Access Compliance Report

Public Rights-of-Way

(Curb Ramps)

Intersection ID: 52448	Main Street: WOODWARD_AV	Cross Street: DOUBLE_OAKS_RD	Location: W
ADA ID: 69AE424843D0	Ramp Type: MedianPerp	Initial Pass/Fail: Fail	Overall Compliance: No
Severity Score: 1.25			
Codes/Mitigation Info/Possible Solution		Field Measurements/Component Compliance

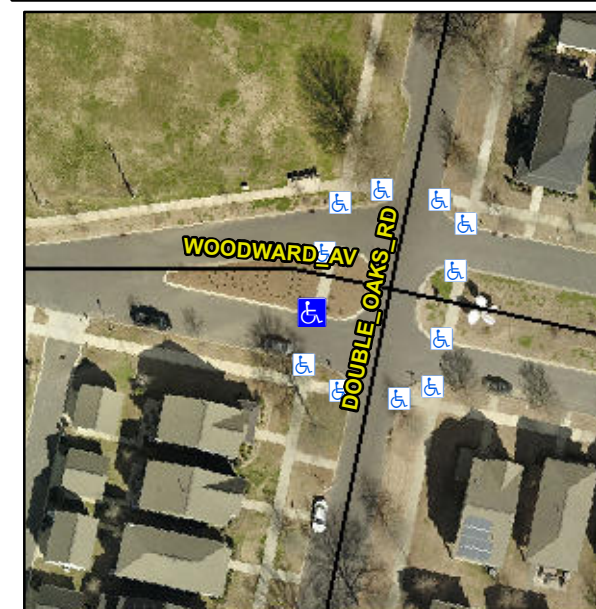
R304.5.3

Compliance	Description	Data	Compliance	Description	Data
N/A	Ramp Length (in)	95.0	Yes	Ramp Slope (%)	6.8
Yes	Ramp Width (in)	63.0	No	Ramp XSlope (%)	2.7
N/A	Flare Type LT	N/A	N/A	Flare Type RT	N/A
N/A	Flare Slope LT (%)	N/A	N/A	Flare Slope RT (%)	N/A
N/A	Flare Traversable LT?	N/A	N/A	Flare Traversable RT?	N/A
N/A	Landing Length (in)	N/A	N/A	DWS Provided?	N/A
N/A	Landing Width (in)	N/A	N/A	DWS Contrast?	N/A
N/A	Landing Slope (%)	N/A	N/A	DWS Length (in)	N/A
N/A	Landing X Slope (%)	N/A	N/A	DWS Full Width?	N/A
N/A	Landing Curb? (Y/N)	N/A	N/A	DWS Offset (in)	N/A
N/A	Shared Landing?	N/A			
N/A	Gutter Ponding?	N/A	N/A	Gutter Slope (%)	N/A
N/A	Gutter Lip Ht (in)	N/A	N/A	Gutter X Slope (%)	N/A
N/A	Painted X Walk1?	No	N/A	Painted X Walk2?	N/A
	X Walk 1 Direction	To S		X Walk 2 Direction	N/A
N/A	X Walk 1 Width (in)	N/A	N/A	X Walk 2 Width (in)	N/A
	X Walk 1 Slope (%)	0.0		X Walk 2 Slope (%)	N/A
	X Walk 1 X Slope (%)	2.5		X Walk 2 X Slope (%)	N/A

Remove & Replace Entire Ramp.
